Access Report

**Mixed Use Development**  
37 Ogilvie Street  
DENMAN NSW

For: Vanessa Green  
Ref: LP\_22420

### 7.3 Doorways Generally

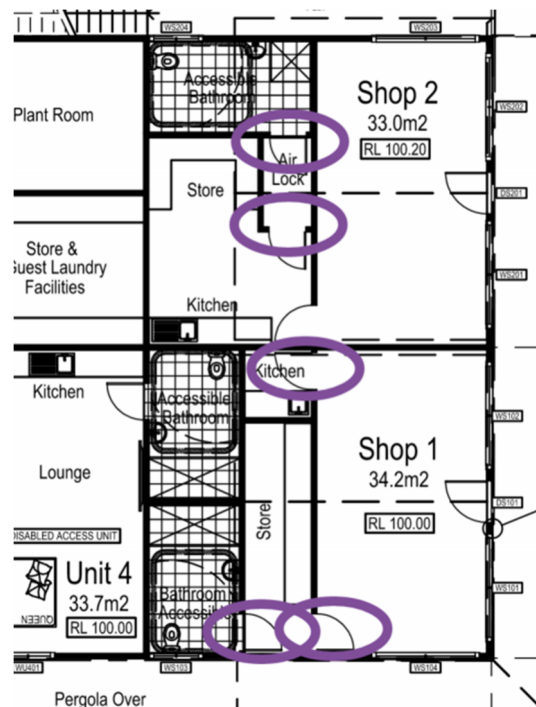
Doorways within the accessible path of travel generally achieve the required circulation areas.

Detailed design should ensure that doorways are provided with the required circulation areas – specifically doors to accessible sanitary facilities within Shop 1 and Shop 2, and Door to Kitchen in Shop 1.

### 7.4 Doorways within Vestibules and Air-locks

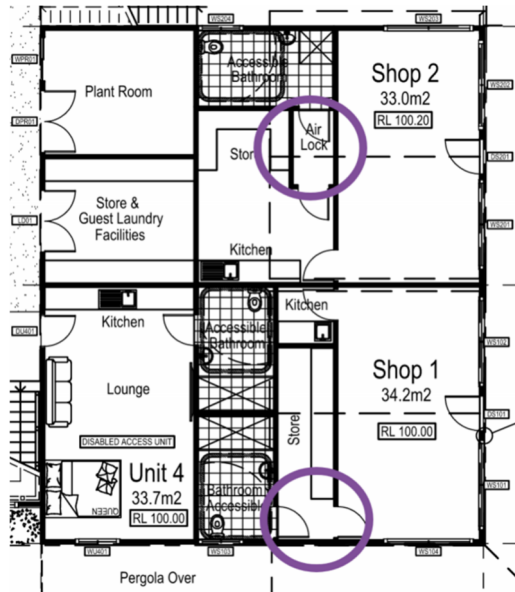
Detailed design to ensure that the required circulation areas are provided within the air-locks to accessible sanitary facilities.

### 8.2 Unisex Accessible Sanitary Compartment

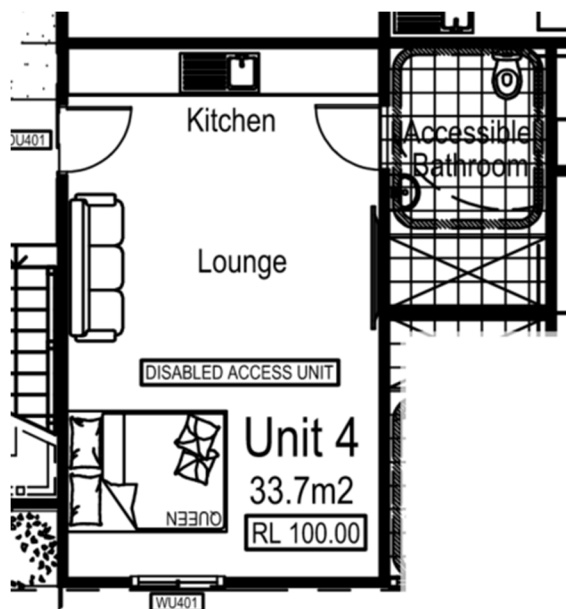
A unisex accessible sanitary facility is provided within each of the retail tenancies – both are a left hand arrangement (detailed design is to ensure a right handed facility is provided).

Overall room dimensions and the set-out of fixtures within the accessible sanitary facilities are capable of compliance with AS1428.1 (2009).
